SOUTH PARK  
DESIGN REVIEW COMMITTEE  
March 25, 2019

# DETAILED DESIGN CHANGES

# PAVILION NORTH ELEVATION - REVISED

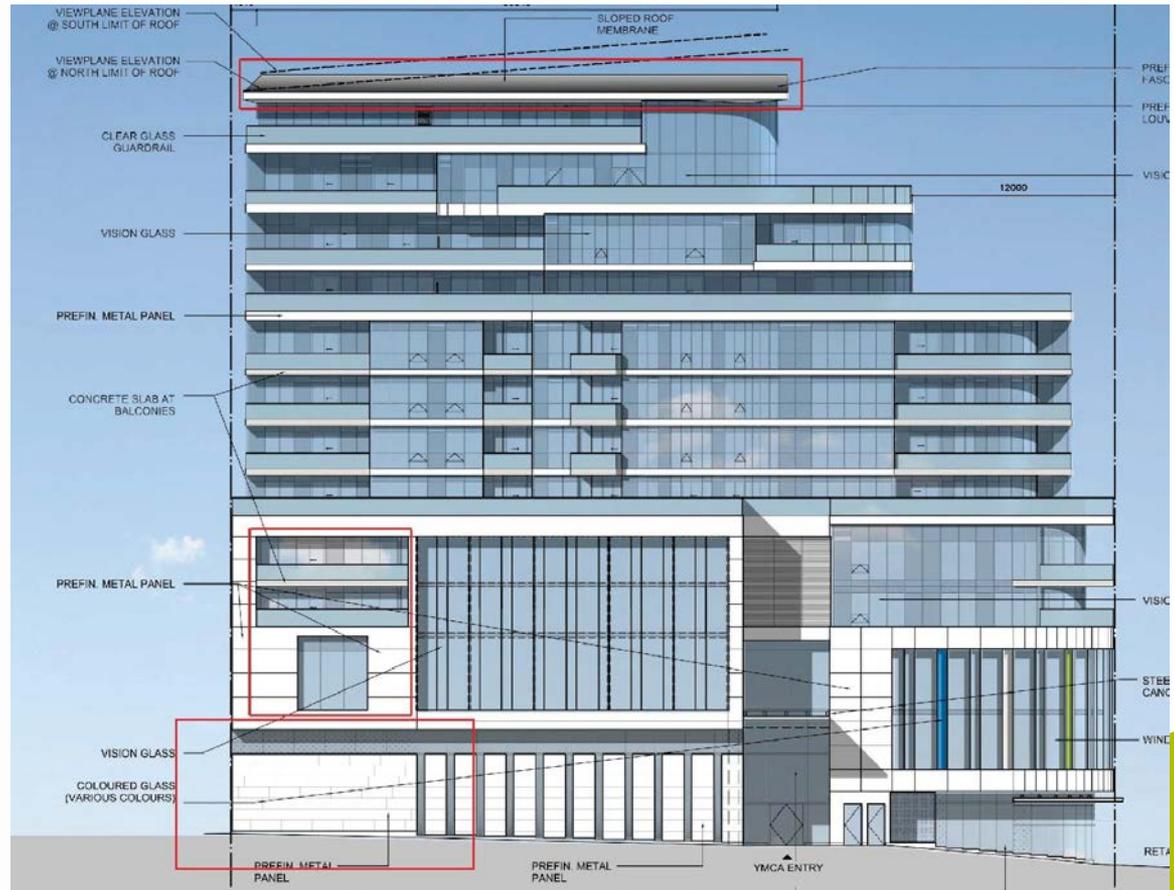
- Inset balcony provided outdoor space for YMCA third floor child care centre
- Glazing spans across ground floor

- Balcony removed from YMCA third floor
  - Daycare not permitted, outdoor space no longer required
  - Studios designed in area
  - Glazing reduced to increase energy efficiency & reduce costs
- Glazing altered on natatorium façade to meet operational safety & security requirements

# EAST ELEVATION – REVISED

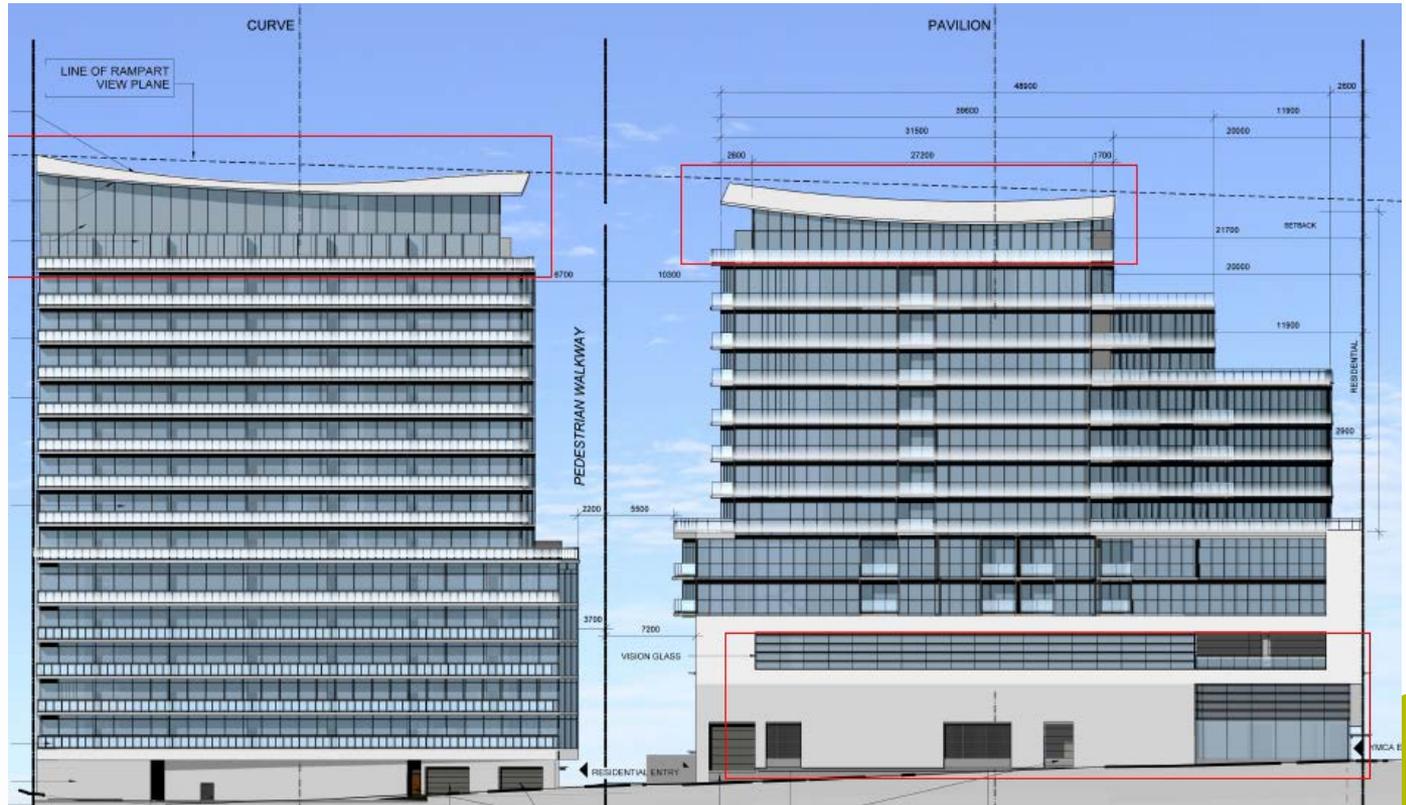
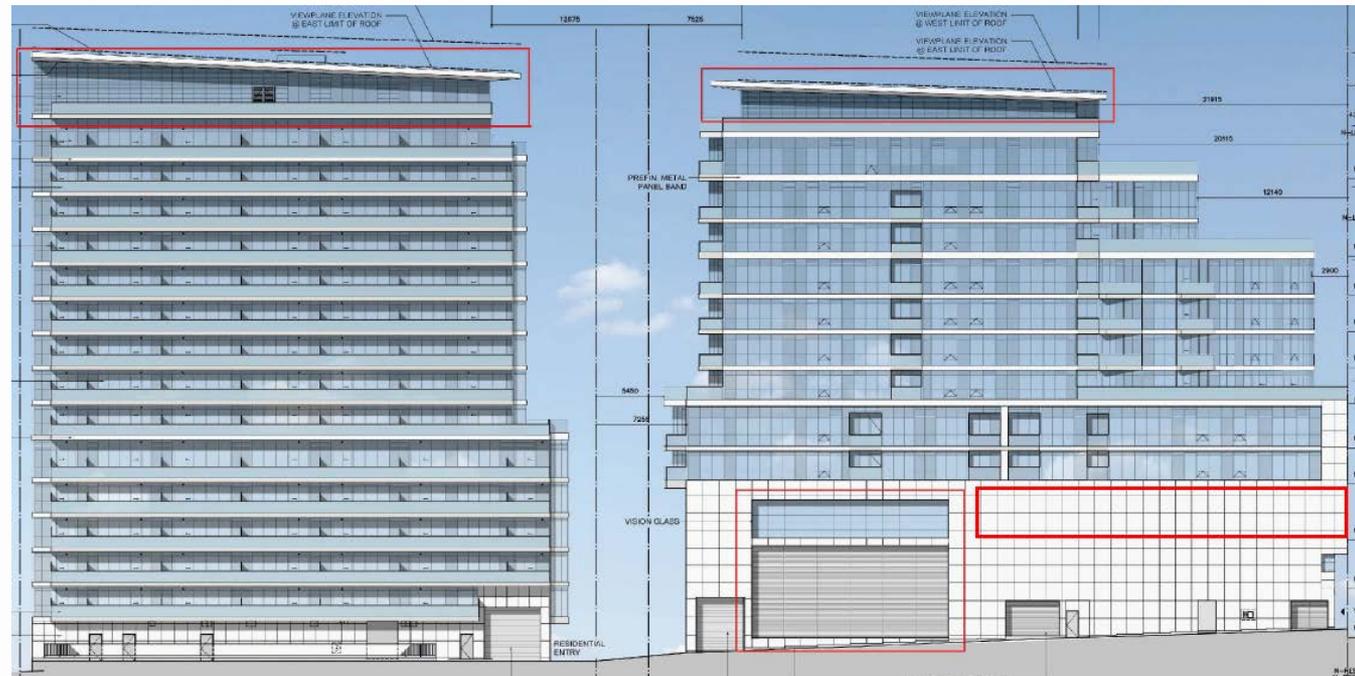
- Vision glass across third floor

- Glazing altered on YMCA third floor
  - Detailed design requirement operationally for YMCA for studios & child care space

# CURVE NORTH ELEVATION – ORIGINAL

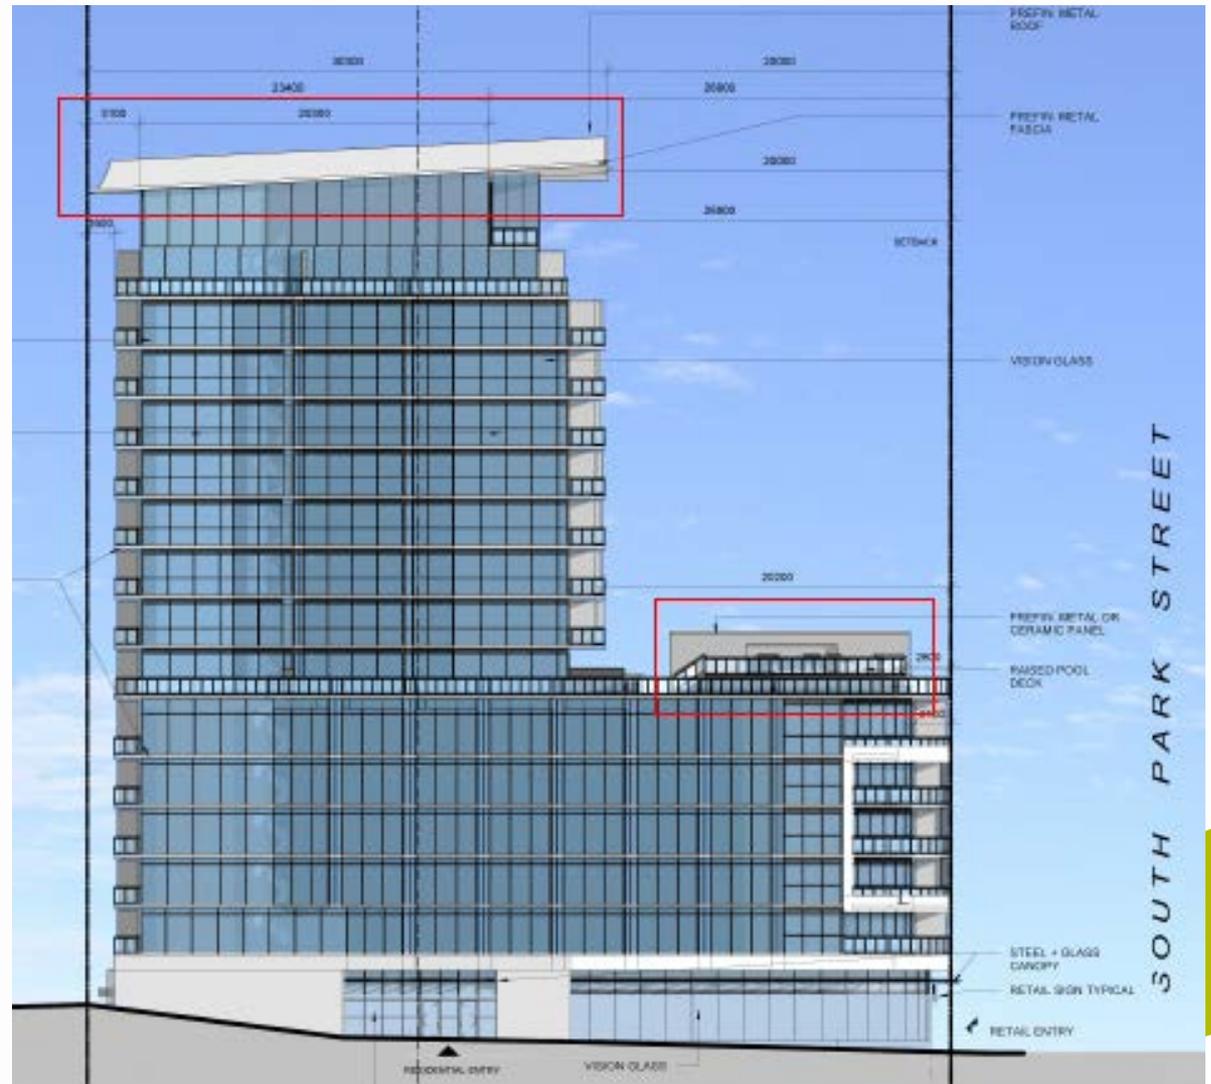
- Pre-finished metal or ceramic panel at raised pool deck

- Raised exterior amenity space shifted west to eliminate double railing condition & to expand usable amenity area
